**Amendments to the Drawings:**

### **REMARKS**

The preceding amendments and following remarks are submitted in response to the non-final Office Action mailed on November 10, 2008. With this Amendment, claims 1-5, 11-13, and 16-17 have been amended, and claims 6-10 and 14-15 have been cancelled. Claims 1-5, 11-13, and 16-19 are thus currently pending in the application. Reconsideration of all pending claims and allowance of the application in view of the present response is respectfully requested.

(Figure 2 of Application)

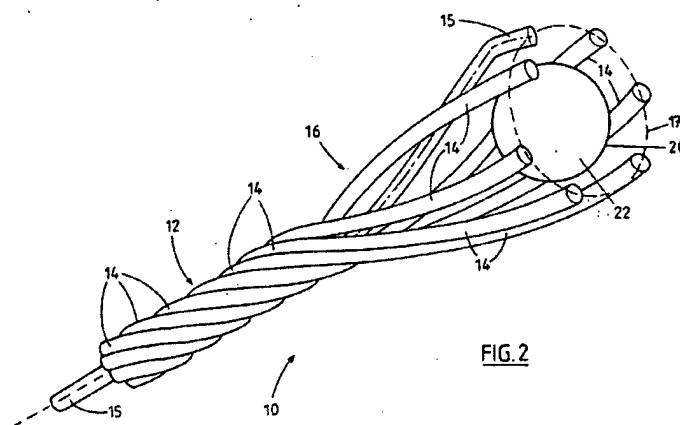
In the Office Action, the drawings were objected to under 37 CFR § 1.83(a). In particular, the Office Action states that the drawings must show every feature of the invention.

With this amendment, Applicant has amended both Figures 1 and 2 to add reference arrow "18," which designates the "cavity" located in the bulbous portion (16) of the cable bolt (10). Support for this amendment can be found, for example, on pages 3-4 of the PCT specification (WO 2005/012691). No new matter has been added as a result of this amendment.

The attached replacement sheets include changes to Figures 1 and 2, and replace the original drawing sheets. In Figures 1 and 2, reference arrow "18" designating the cavity located in the bulbous portion (16) of the cable bolt (10) has been added.

Specifically, independent claims 1, 11, 12 have each been amended to now recite “a plurality of rigid elements each including an outermost surface,” and that “all strands in each bulbous portion extend at least in part around the outermost surface of a rigid element contained in the bulbous portion.” Independent claim 16 has also been amended to now recite “a plurality of rigid elements each including an outermost surface,” and that “all the strands in the pre-formed bulbous portion extend at least in part around the outermost surface of a rigid element contained in the bulbous portion.” Method claims 13 and 17 have also been amended to now require “wherein all the strands in the (each) bulbous portion extend at least in part around the outermost surface of a rigid element contained in the bulbous portion.” Support for these amendments can be found, for example, on page 3, lines 19-21 and in Figure 2 of the present application (reproduced below), which shows all of the outer strands (14) and the center strand (15) extending at least in part around the outermost surface (22) of a rigid element (20) contained in the bulbous portion (16).
